Mitigation Plan

Mushroom Meadow Mitigation Site

Caswell County, North Carolina
Roanoke River Basin HUC 03010104
DMS Project ID No. 100192
Full Delivery Contract No. 200204-01
USACE Action ID No. SAW-2021-00348
NCDWR No. 20210400, V1

Subject: Mitigation Plan
Mushroom Meadow Mitigation Project, Caswell County
Roanoke River Basin HUC 03010104
USACE Action ID SAW-2021-00348/NCDWR 20210400, V1

Figure 10: Reference Reach Map
Mushroom Meadow Mitigation Site
Roanoke 03010104
Caswell County, North Carolina
December 2022

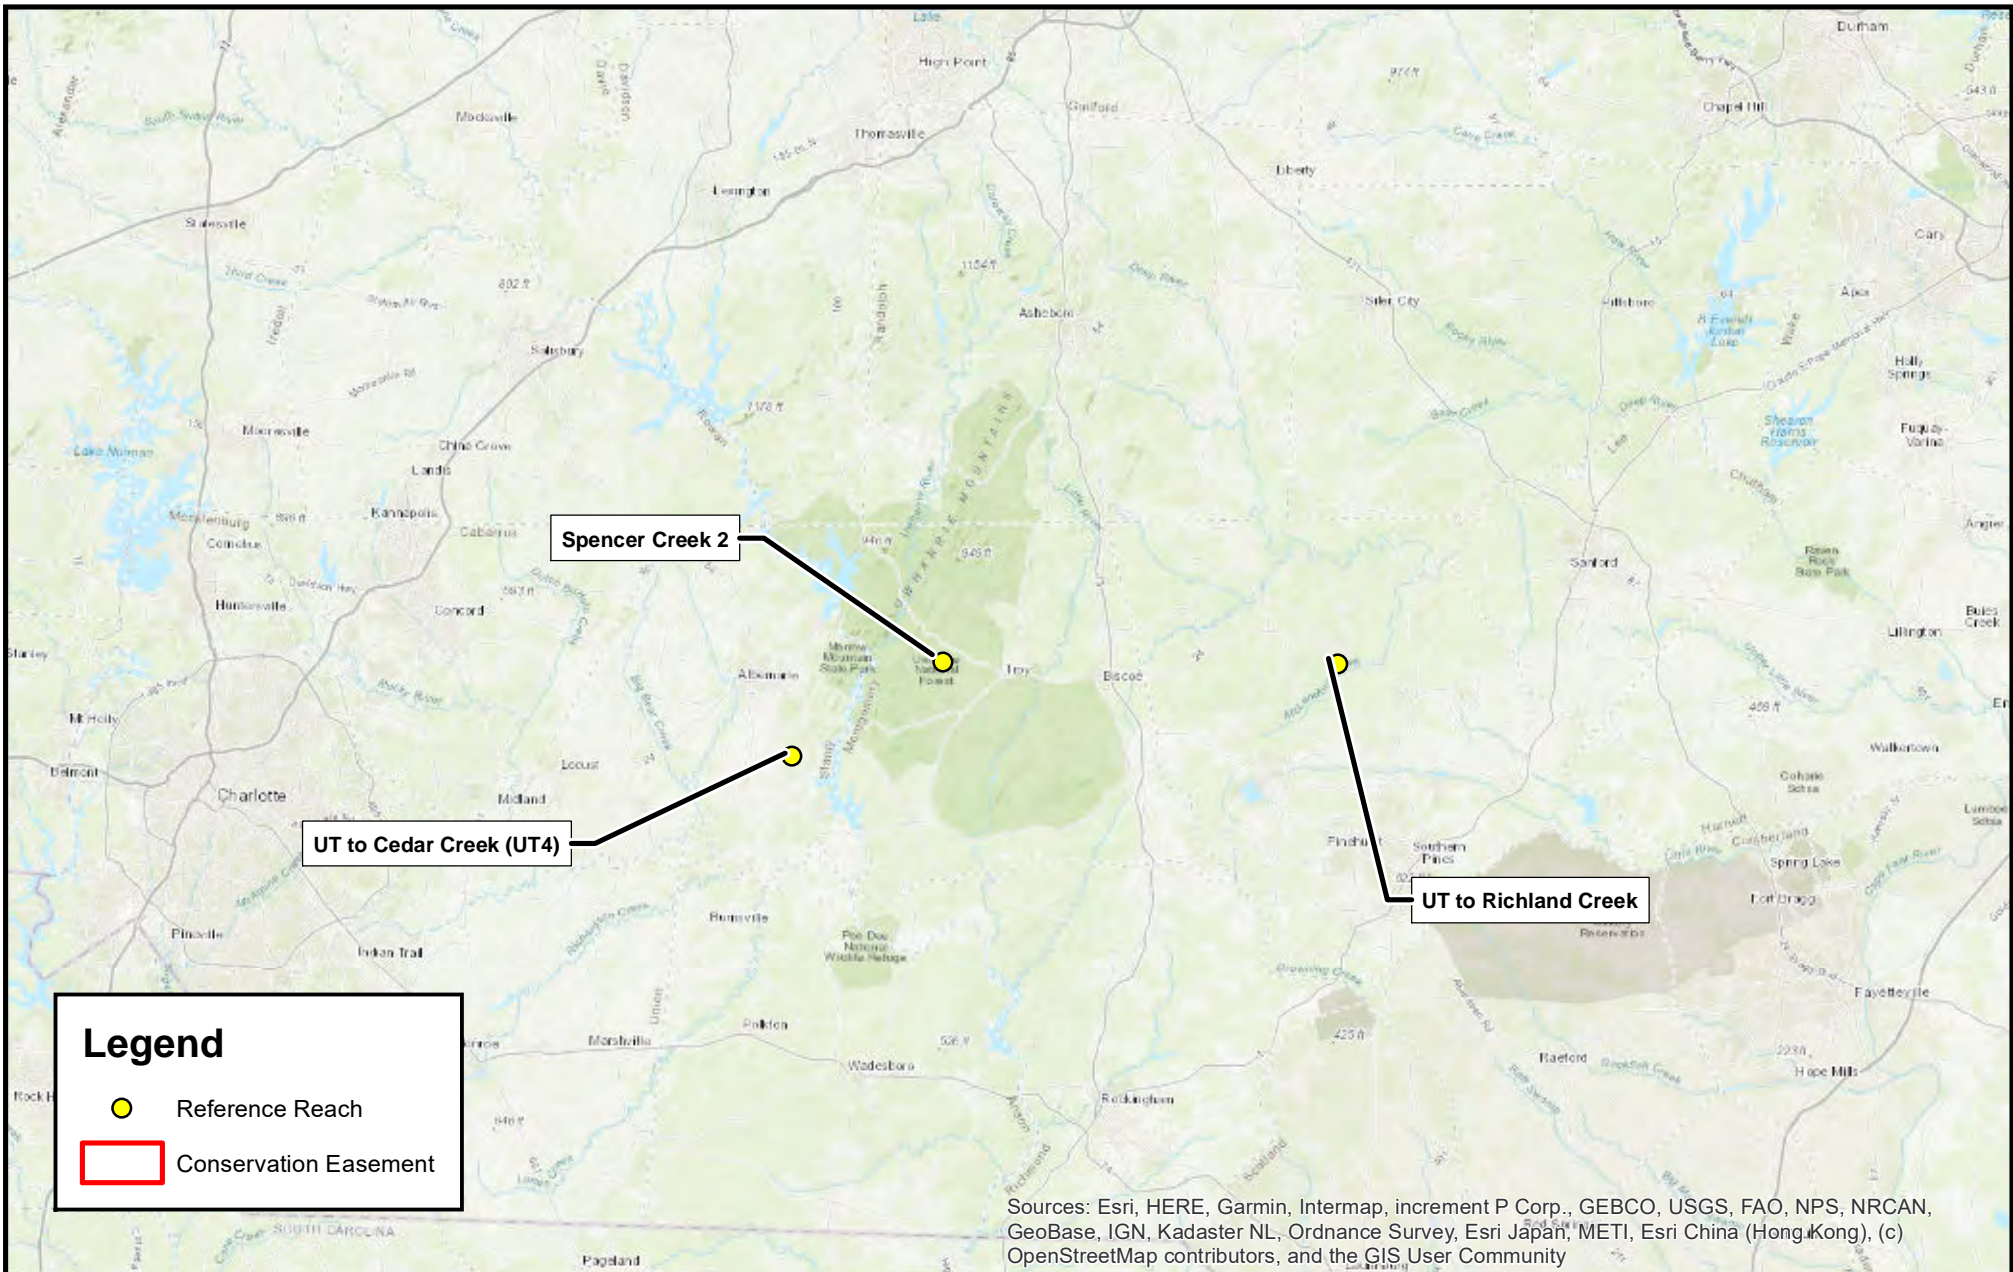
20. Page 40, Table 17 – There are two UT 1R2a listed, please correct the second to R2 or R2b. **Updated second UT1 R2a to UT1 R2.**
21. Figures – Please add reference sites and callout for the River Bend site on an included or new figure. **Added River Bend site to Figure 1 and 3. Added a Figure 10 with reference site locations.**

01/11/2023 DATE	39077.34 PROJECT NO.	PSH-01.3 SHEET
--------------------	-------------------------	-------------------

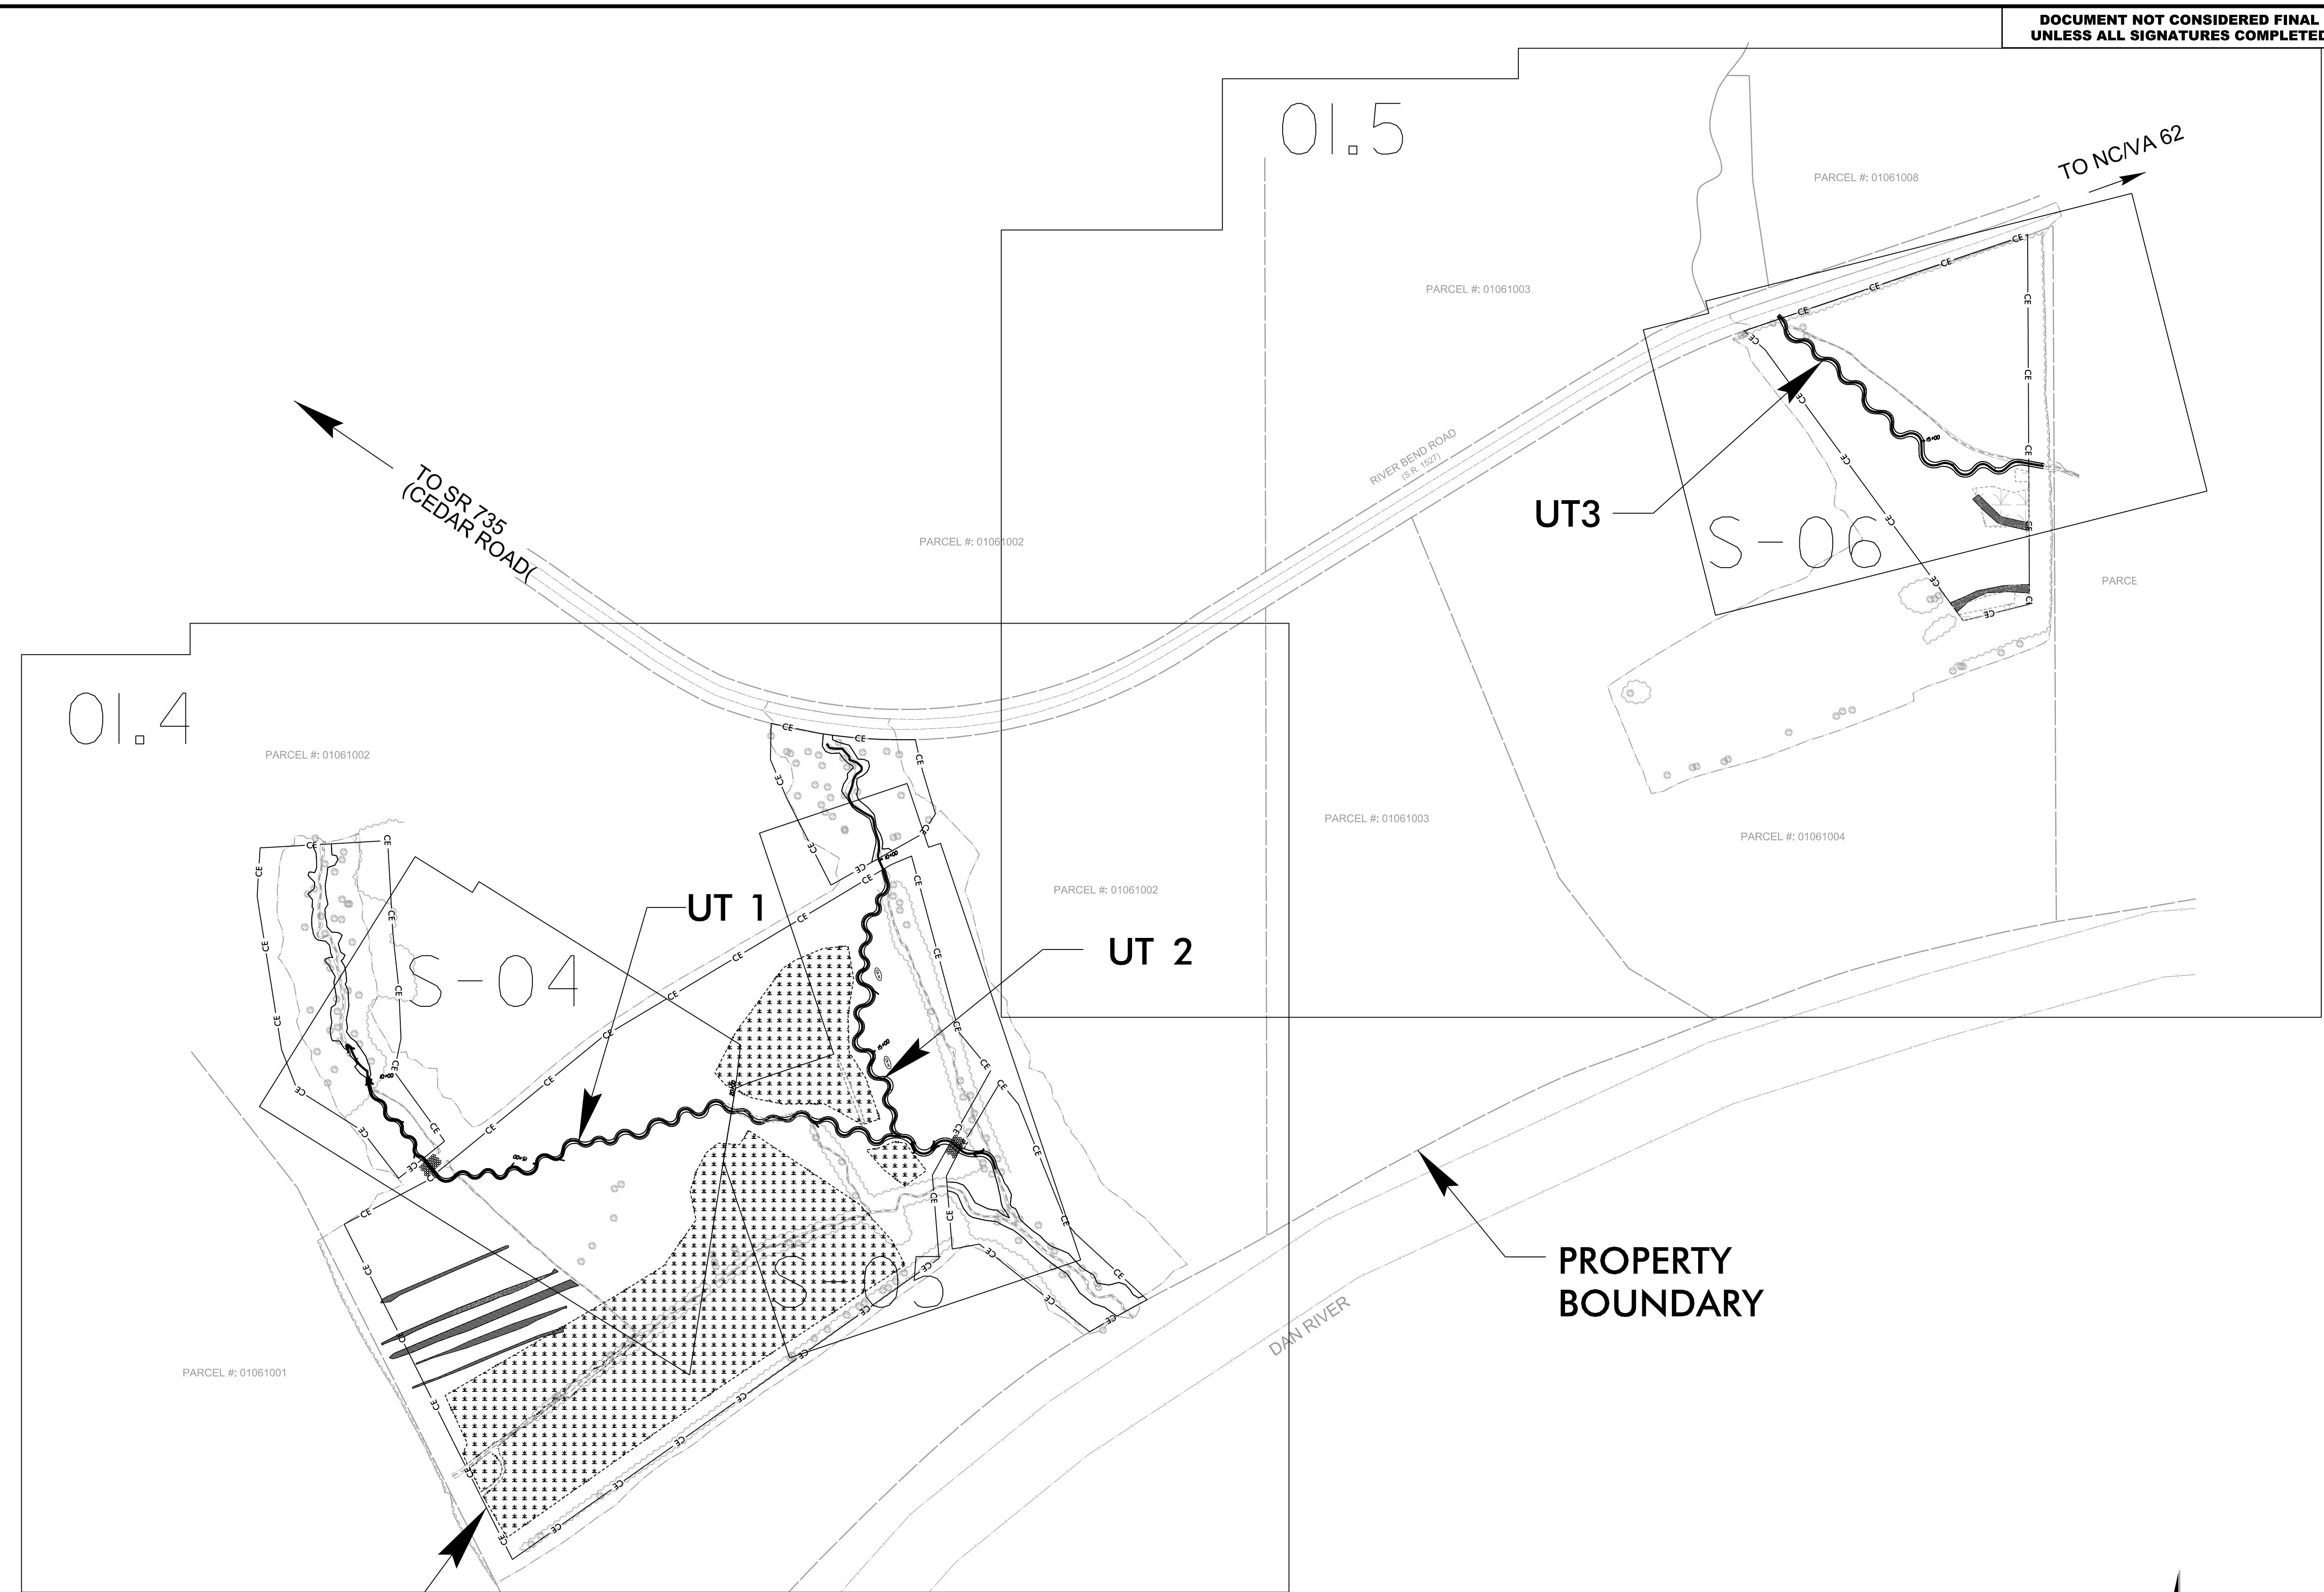
- e. Please add a figure note regarding additional random veg plots and fixed photo points. **Added note to Figure 9.**
25. Sheet PSH-01.3 – Looking at the property boundary east of UT3 and Wetlands 3 & 4, why was the proposed easement setback from the property line? This appears to be a missed opportunity to capture additional wetland and stream on the site. **The landowner specifically requested there be a setback from the property boundary.**
